**Federal Highway
Administration**

December 13, 1999

Refer to: HMHS-B62

In response to your March 17 letter to Mr. Richard Powers of my staff, you were advised that your precast concrete barrier, called GPLINK, could be accepted for use in the United States if it performed acceptably in the two full-scale crash tests recommended in the National Cooperative Highway Research Program (NCHRP) Report 350, "Recommended Procedures for the Safety Performance Evaluation of Highway Features" for a test level 3 (TL-3) barrier. At that time, you had already completed and reported to us a successful test with a small car (NCHRP Report 350 test 3-10), and needed only to complete NCHRP Report 350 test 3-11, an impact with a 2000-kg (4400-pound) pickup truck at an impact angle of 25 degrees and an impact speed of 100 km/h (62.2 mph). On October 6, you sent Mr. Powers a copy of a test report prepared by the Swedish National Road and Transport Research Institute (VTI) which reported the results obtained for test 3-11.

Technical description -- road barrier

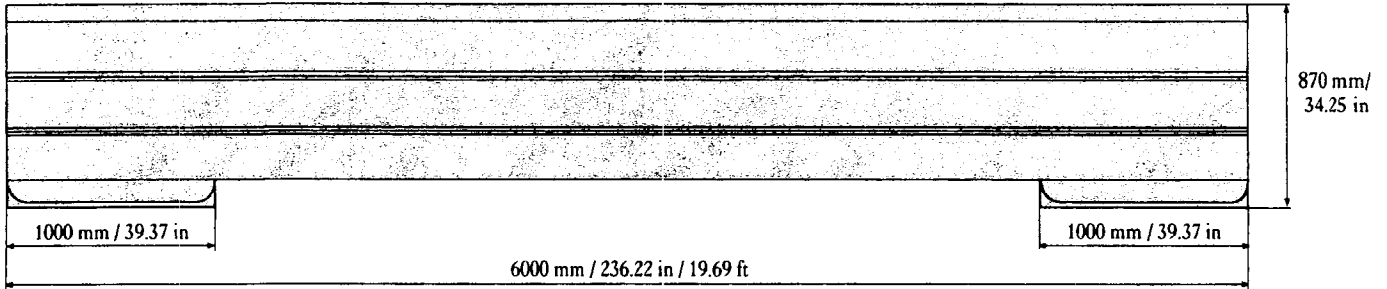
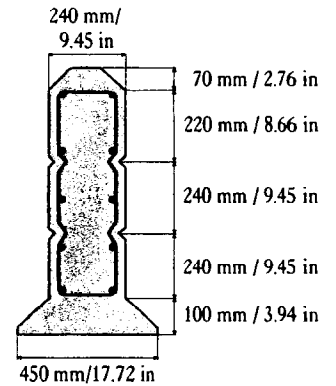
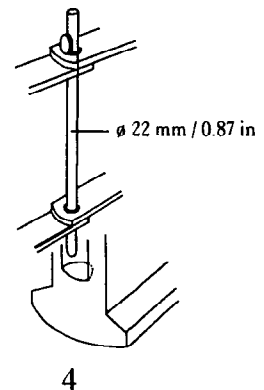
After reviewing both test reports, we can agree that each test met the evaluation criteria recommended in NCHRP Report 350. Both vehicles were redirected upright with no passenger compartment intrusion. For test 3-10, the theoretical occupant impact velocities were 4.1 m/s in the longitudinal direction and 6.6 m/s in the lateral direction. Longitudinal and lateral ridedown accelerations were 3.3 G's and 4.5 G's, respectively. Barrier deflection was reported as 420 mm (16.5 inches). For test 3-11, the comparable longitudinal/lateral values for occupant impact velocities were 4.4 m/s and 6.9 m/s and for ridedown accelerations, 13.5 G's and 15.4 G's. Barrier deflection for the pickup-truck test was 1760 mm (69.3 inches). Roll, pitch and yaw angles were 36.2 degrees, 24.7 degrees and 75.8 degrees, respectively.

The tested GPLINK precast concrete barrier segments were 6-m (approximately 20-feet) long and 870-mm (34.25-inches) high. Width at the base supports was 440 mm (17.3 inches) and the barrier itself was 240-mm (9.45-inches) thick with vertical sides. Adjacent segments were connected with 680-mm (26.8-inch) long, 22-mm (0.87-inch) diameter steel rods inserted through holes in steel plates, two of which are cast into each barrier segment. Steel reinforcing consists primarily of 10 16-mm (0.63-inch) steel bars. These and other design details are shown in Enclosure 1 to this letter.

Based on our review of the information you provided, we find the GPLINK precast concrete barrier, as tested, to meet the requirements for an NCHRP Report 350 test level 3 (TL-3) traffic barrier. It may be used on the National Highway System in the United States when such use is requested by the governing transportation agency. Federal laws currently require steel products and products containing significant amounts of steel to be manufactured in the United States using U.S. steel. We assume that you plan eventually to manufacture the GPLINK barrier in this country. Since it is a proprietary product, its use on Federal-aid projects, except exempt, non-NHS projects, is subject to the conditions listed in Title 23, Code of Federal Regulations, Section 635.411, a copy of which is enclosed (Enclosure 2) for your reference. Please do not hesitate to contact Mr. Powers by e-mail at richard.powers@fhwa.dot.gov or call him at (202) 366-1320 if you have any questions regarding this letter.
